Subject: Supplement No. 2
Geotechnical and Geologic Investigation
Lots 11, 19, and 20, Block 15, Tract No. 7803
1749 and 1751 Malcolm Avenue and 1772 Glendon Avenue
Los Angeles, California

GEOLOGY AND SOILS REPORT CORRECTION LETTER

LOG # 89430-01
SOILS/GEOLOGY FILE - 2
LIQ/PFRSA

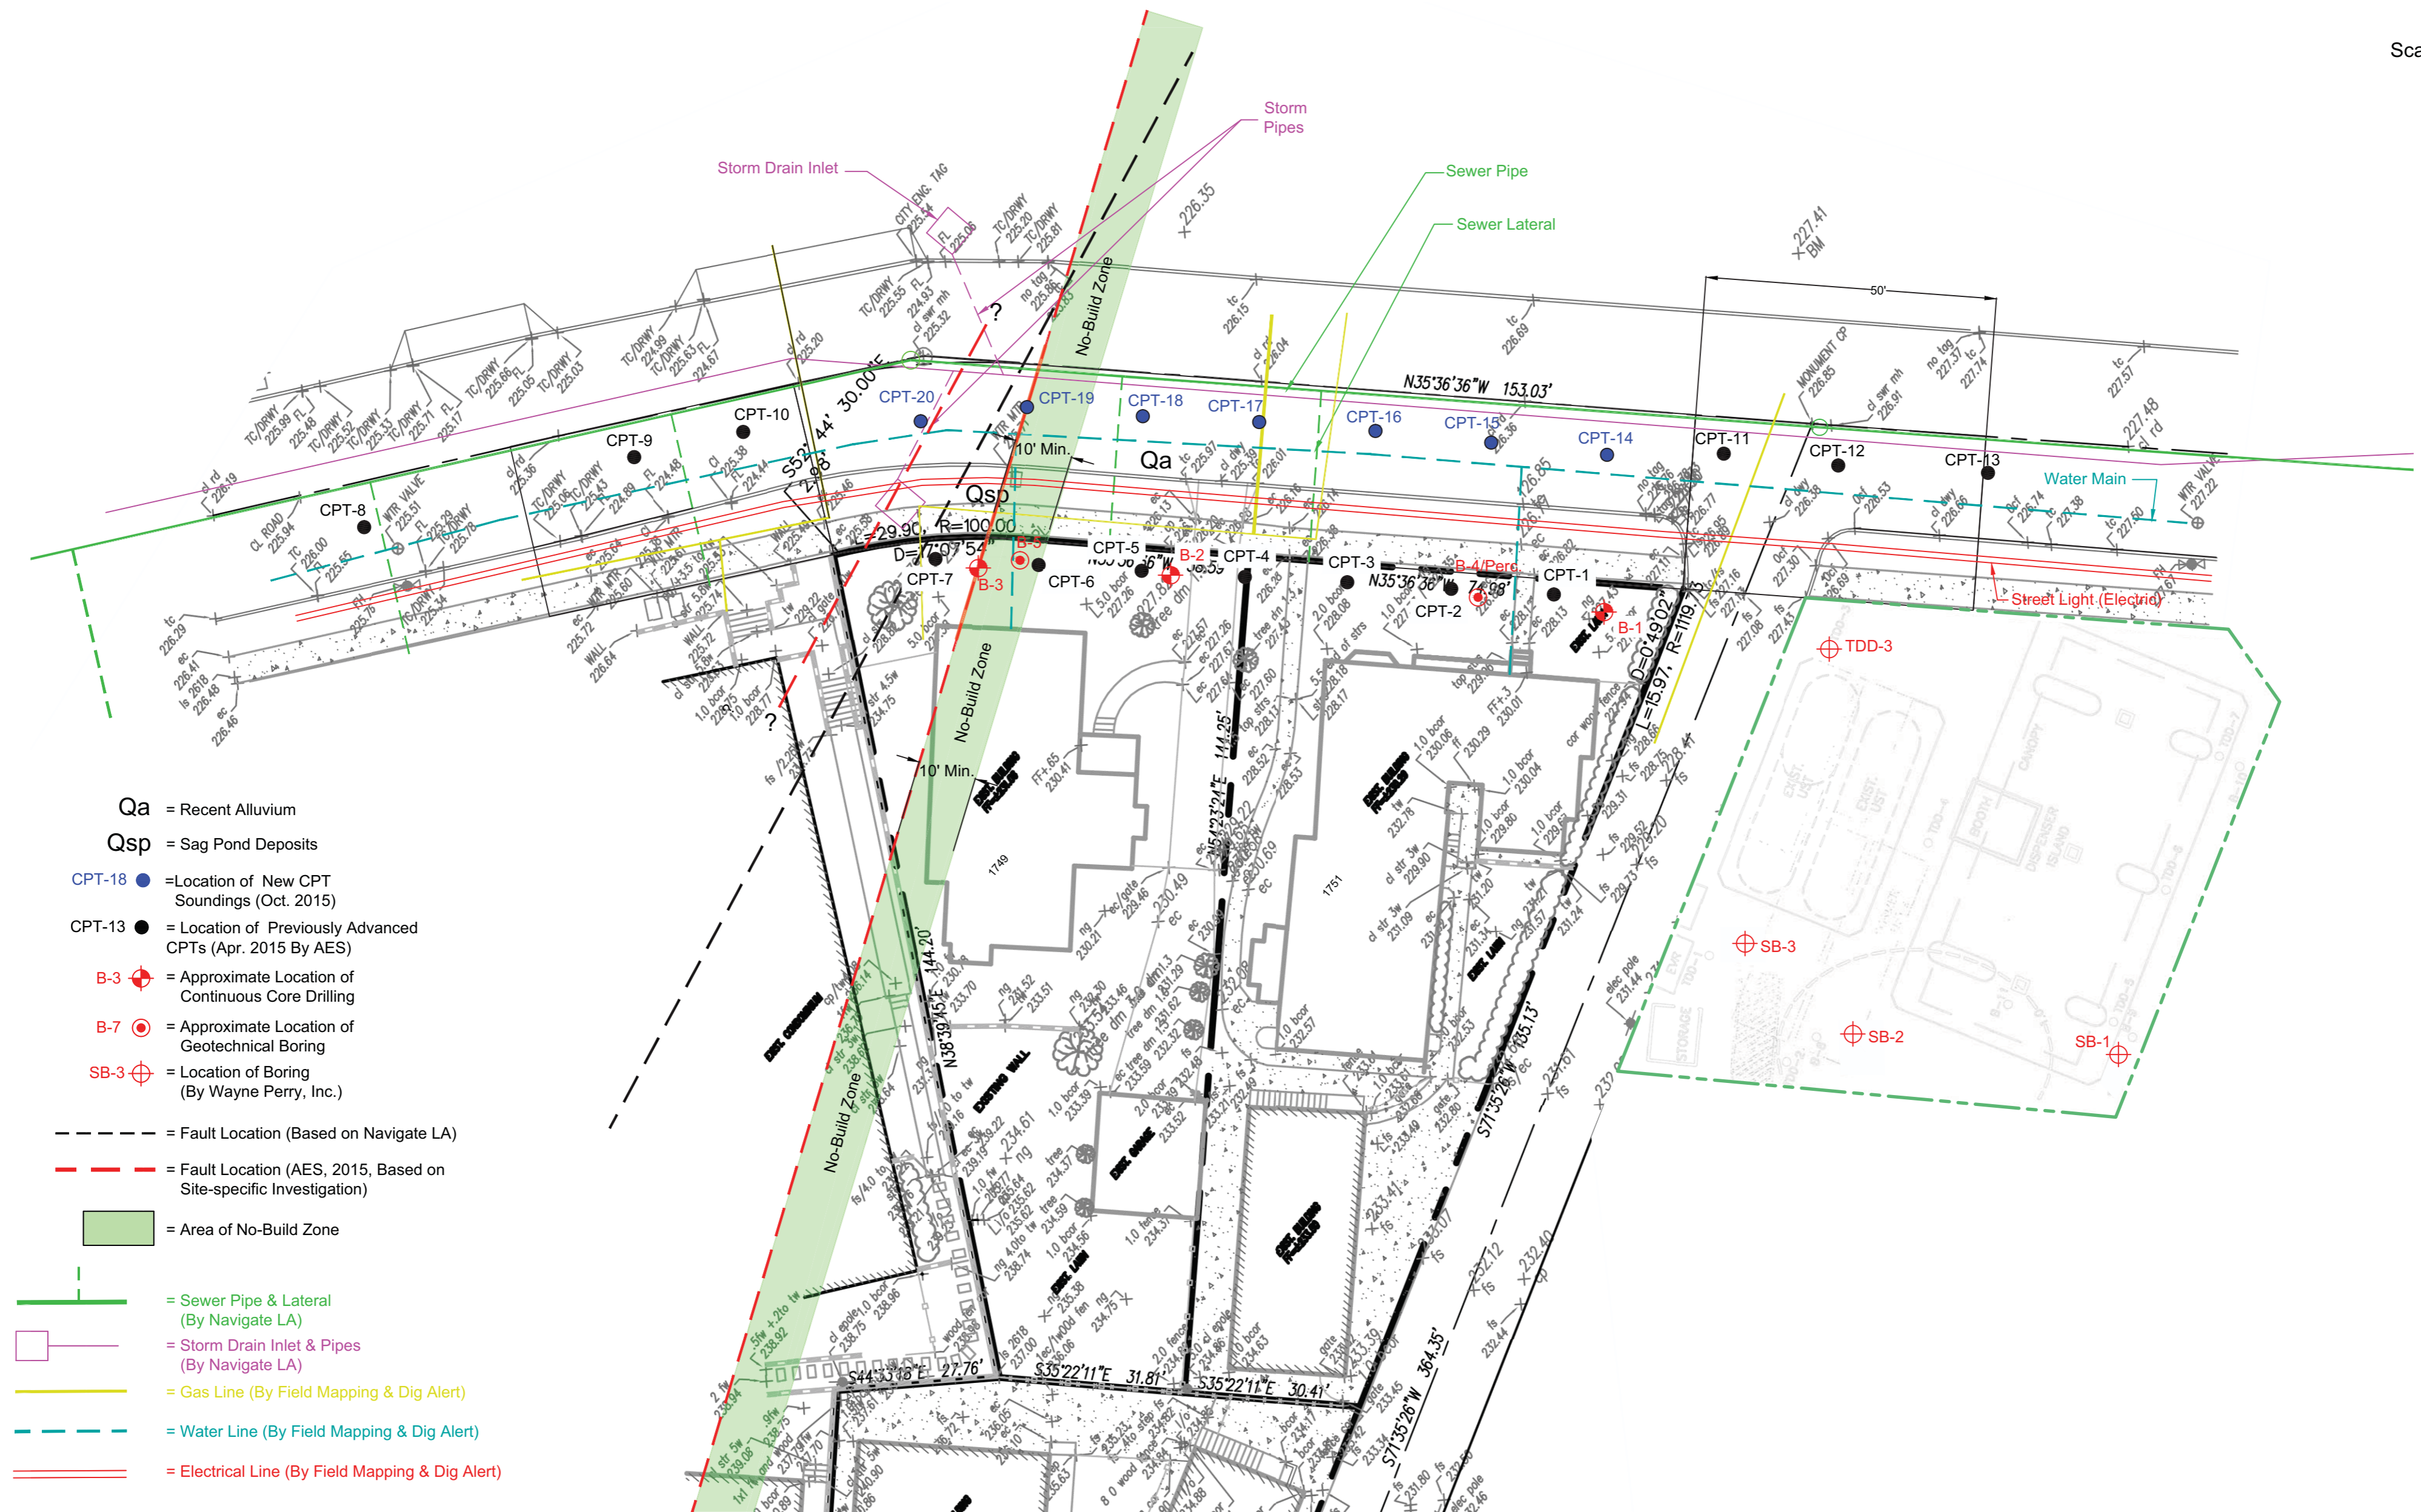
1. The southern most fault closest to the proposed habitable structures identified by the consultants appears to be located between continuous core boring B-3 and CPT-7 in transect B-B' and between CPT-18 and CPT-10 in transect A-A'. As no direct evidence of the orientation of the fault has been provided, the most conservative orientation of the fault trace appears to be a fault that is located just north of B-3 and just south of CPT-19. Provide a revised possible fault orientation and setback; or, provide additional exploration to confirm the fault's trend as interpreted by the consultant.

2. As no exploration has been performed west of transect B-B' to identify the fault trend, the consultants should provide an opinion as to possible variability (non-linear, flowering, etc.) in the fault trend west of transect B-B', with appropriate setback.

1. We have hereby revised the fault orientation to reflect the most conservative orientation, based on that fact that direct evidence or observation of the actual orientation of the fault with the exploration methods used is not possible. The revised fault orientation passes through B-3 and CPT-19.

However, now that the most conservative possible fault orientation is being used as a basis for engineering design of the buildings, we have reduced the no-build setback from twenty to ten feet, as was originally recommended in our 7/21/15 original report. This reduction in setback back to ten feet, based on the most conservative possible fault orientation, was discussed and verbally agreed upon with Mr. Schneidereit of LADBS in our meeting on 1/13/16.

2. Based on the presence of abundant fine-grained sag pond deposits north of the two faults encountered during our exploration, it is our opinion that the main trace of the Santa Monica fault lies north of the study area. This corresponds to the geomorphic and topographic evidence of the main trace being along the south-facing escarpment that forms the front lawn of the LDS temple, the northwestward projection of which extends north of the study area. The project area is likely located on the south part of a localized zone of transtension along the generally left-lateral strike-slip fault zone, related to the northwestward bend in the main fault trace one block east of the study area (Miles Kenney, 2014; Scott Lindvall, personal communication, Richard Crook, Jr., personal communication). It is therefore the opinion of the undersigned that the possibility of flower structures or non-linear variability west of the encountered fault is minute, since we consider this fault to be a splay of the main fault north of the project area. Furthermore, it is our opinion that any non-variability west of the study area (B-3) to the north property limit (a span of 50 feet) will be within the established ten-foot setback zone.

FINAL GEOTECHNICAL SITE PLAN

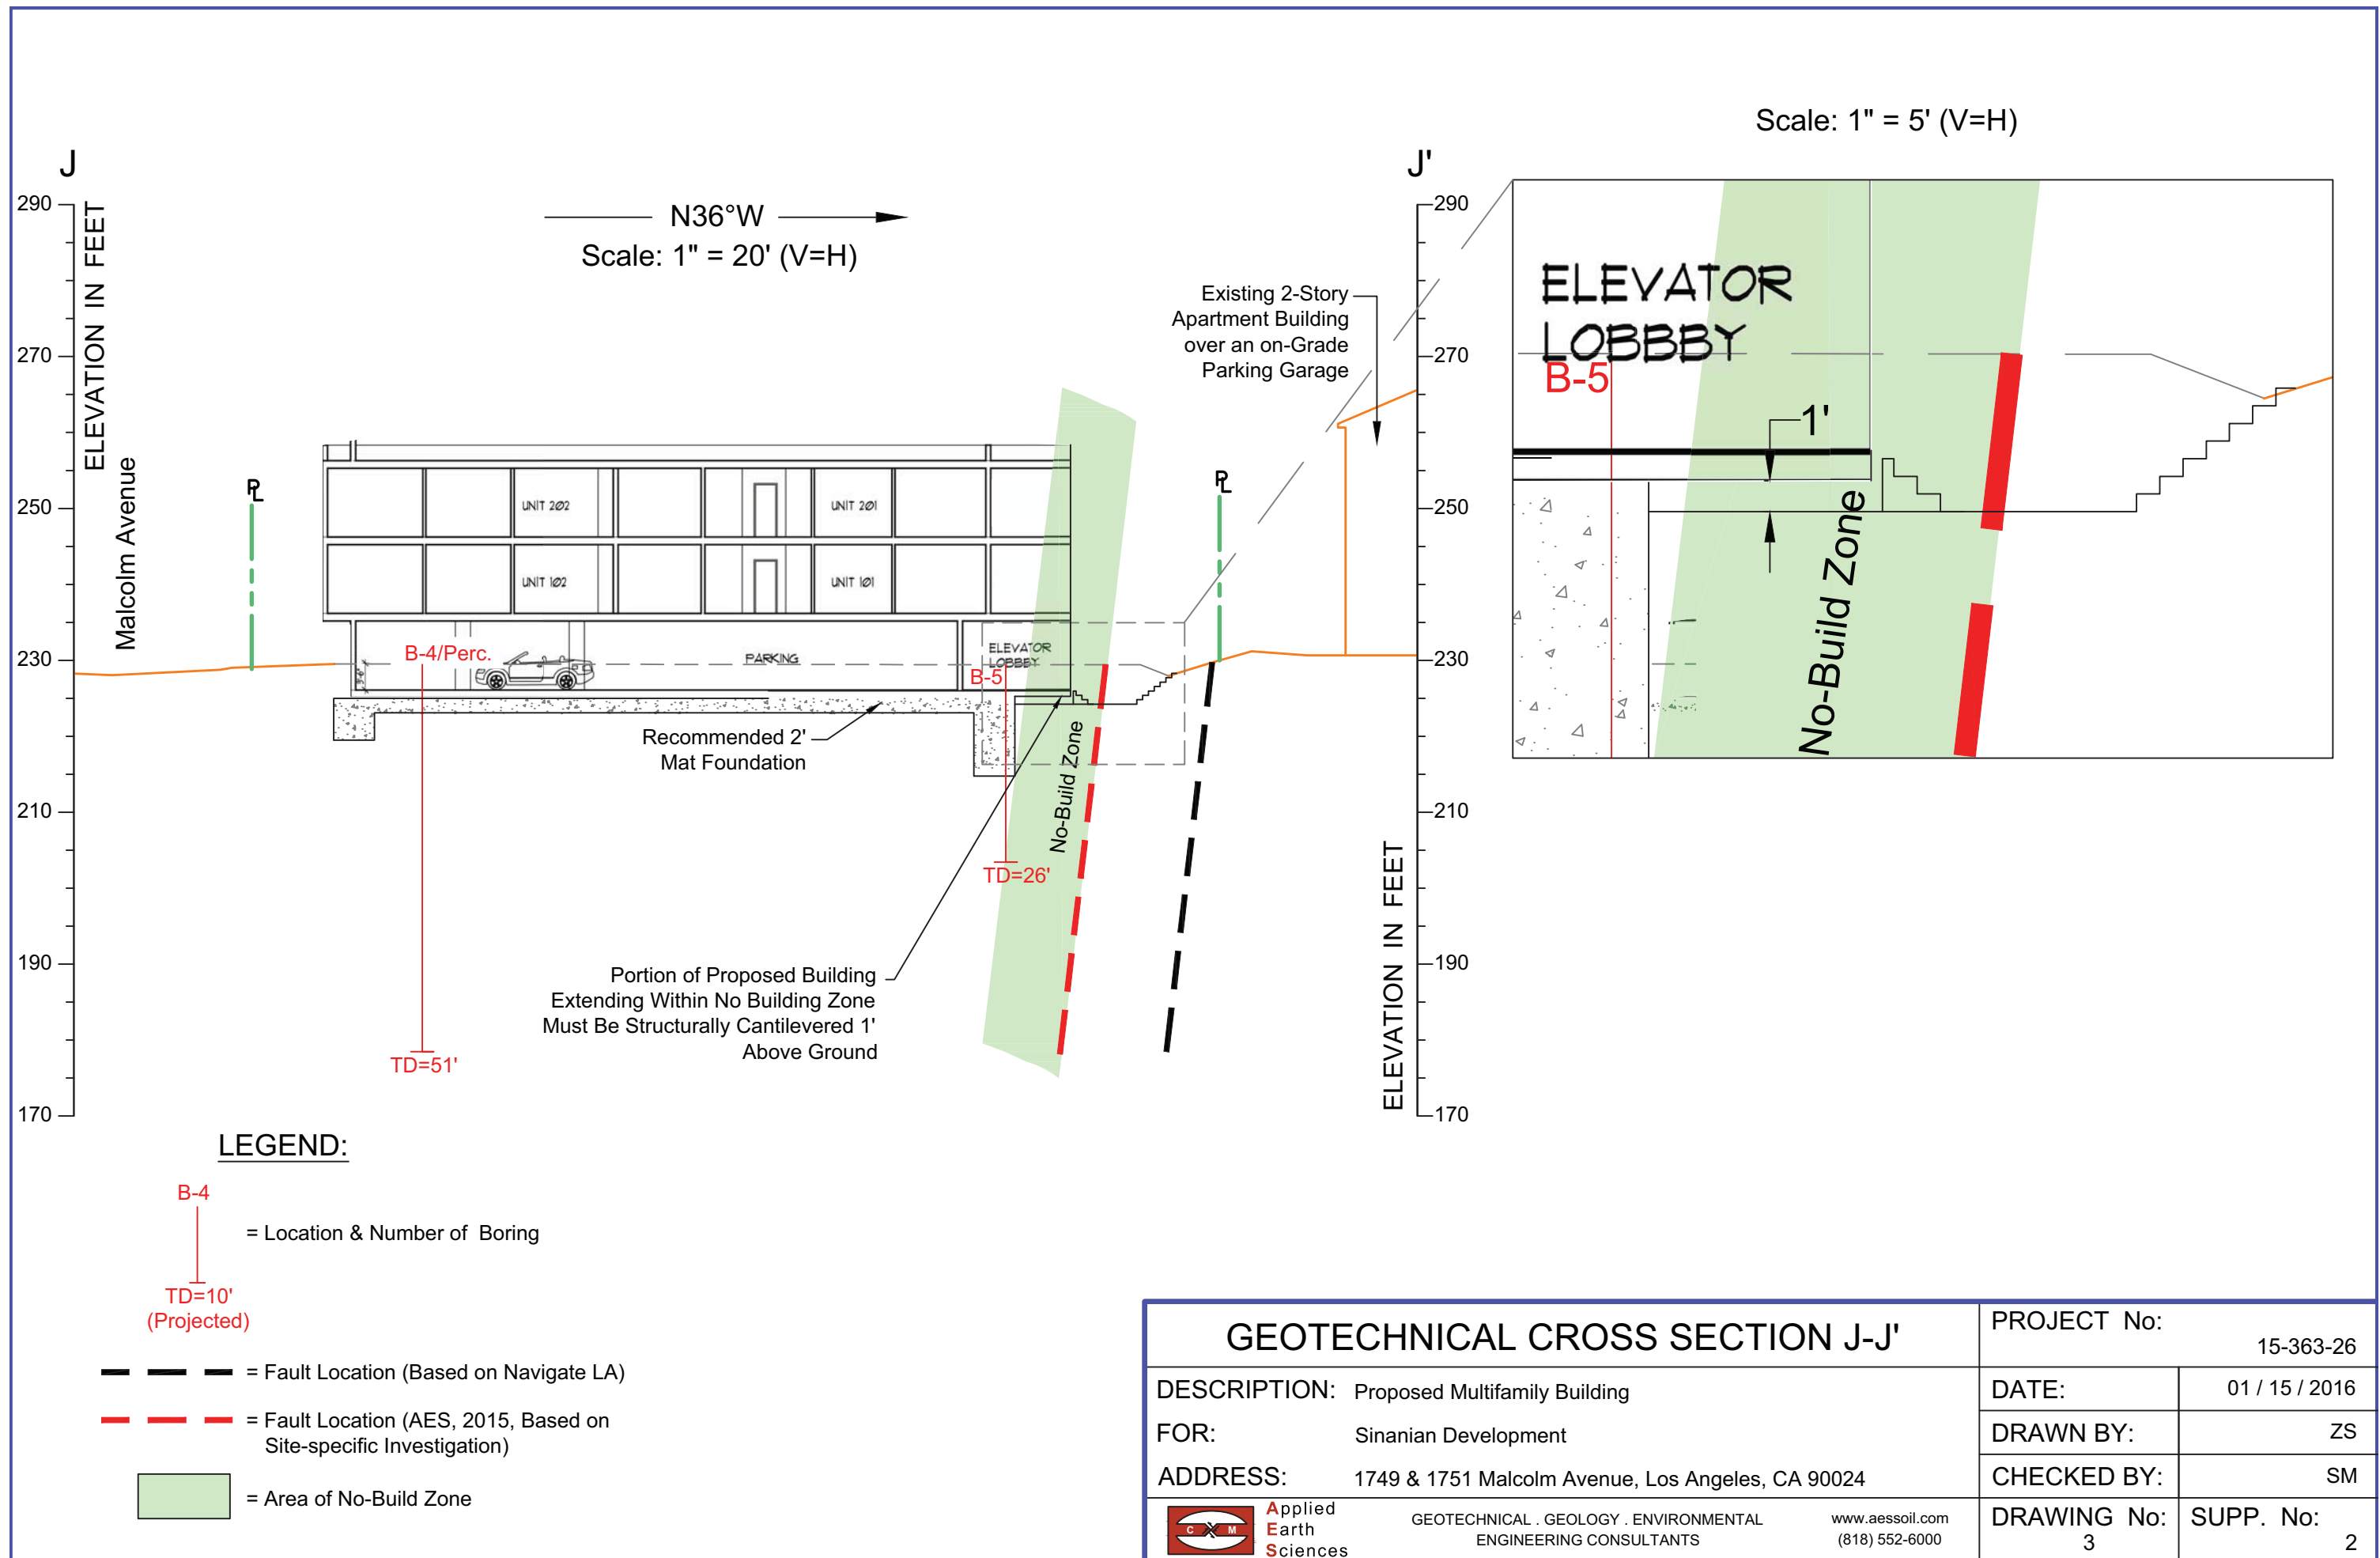
3. As the consultants recommend building a cantilevered structure within the "No-Build Zone", the consultants shall provide recommendations as to the maximum vertical and horizontal offset of the fault; and, a recommendation for vertical and horizontal space to be maintained below the cantilevered structure. Provide a plan that depicts the required space maintained below the cantilevered structure. Note: The current plan appears to show a lobby with doorways in the cantilevered area. No at grade structures can be connected to the cantilevered section of the proposed building.

undersigned that the maximum vertical offset along this fault for a single earthquake event is 12 inches. We have depicted the cantilevered portion of the building as such: the area around the proposed new building which will be cantilevered within the setback zone shall be subject to minor grading/shaving of the ground surface, confined to the subject property, such that the cantilevered part of the proposed building will have a minimum of 12 inches clearance above the finished ground surface. Any appurtenant stair or bridge structures that provide access to the lower lobby level of the main building shall be structurally separate from the main building. We have revised our drawings to reflect this requirement; see revised Geotechnical Site Plan and new Geotechnical Cross Sections J and K attached.

In addition, to address off-fault deformation we have recommended a 2-foot thick mat slab foundation for both proposed new buildings, as previously discussed in prior Supplemental Report No. 1. Structural engineering plans for the proposed buildings shall be subject to our review and official stamp and signature approval to ensure that the requirements as set forth in our reports are adhered. Lastly, continuous deputy inspection by a geologist representative of this office during the grading phase of the course of construction shall be required.
